# 802.3ch Communication link access latency – Table 78-4

July 10, 2019

Jim Graba

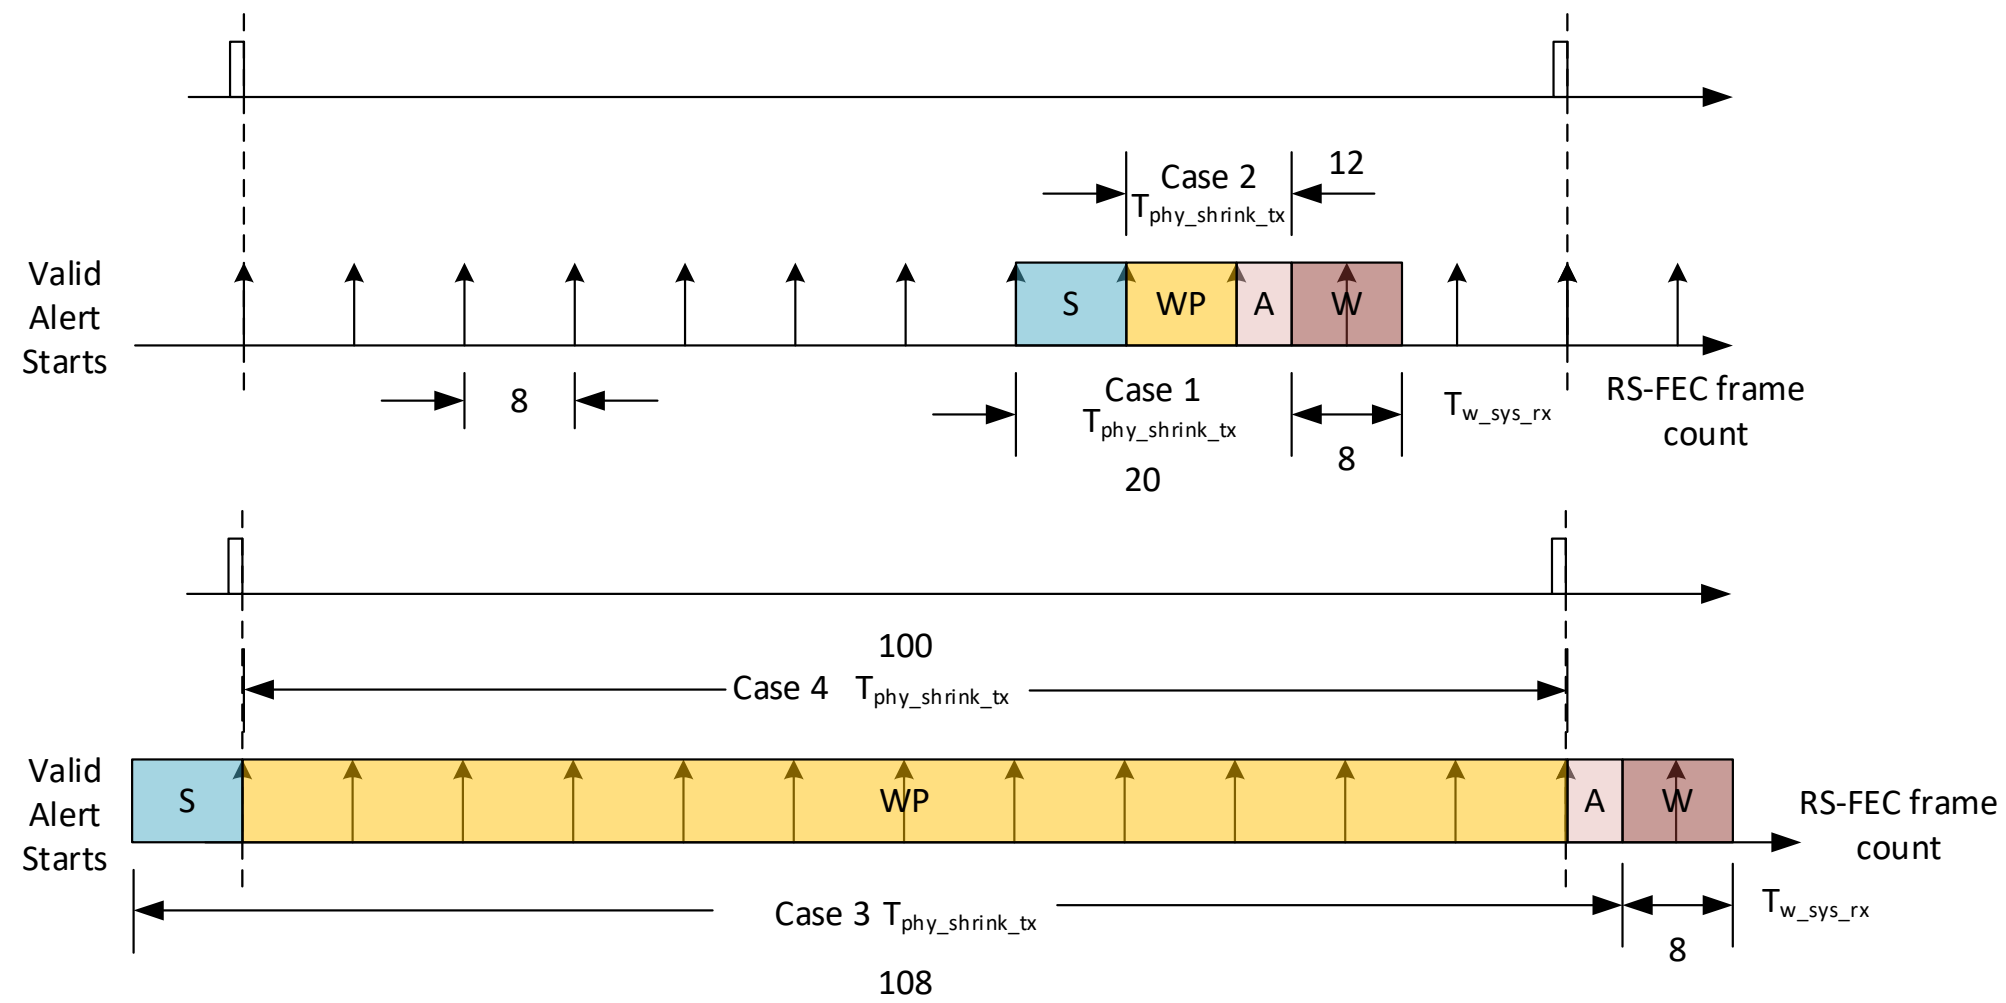
- Pete Anslow generated a comment (#22) on D2.0, Table 78-4 having blank columns.
  - I agree that the columns shouldn't be blank.
  - But only the  $T_{\text{phy\_shrink\_rx}}$  column should be zero.
  - The  $T_{\text{phy\_shrink\_tx}}$  column should be non-zero.
- Outside comment #22 scope
  - $T_{\text{w\_sys\_tx}}$  and  $T_{\text{w\_phy}}$  columns' intersection with Case-3 and Case-4 should be different
- Justification follows.

- The LPI latency pattern is the same as for 2.5G/5G/10G
- $T_{w\_sys\_rx} = T_{phy\_wake}$  (already in D2.0)
- $T_{phy\_shrink\_rx} = 0$ . Received Wake length on the MDI is the same as the received length on the xMII.
- From Figure 78-5 – LPI timing parameters ...
  - $T_{w\_sys\_tx} = T_{w\_sys\_rx} + T_{phy\_shrink\_tx} + T_{phy\_shrink\_rx}$
  - $T_{w\_phy} = T_{phy\_wake} + T_{phy\_shrink\_tx}$
  - $T_{w\_sys\_tx} = T_{w\_phy}$
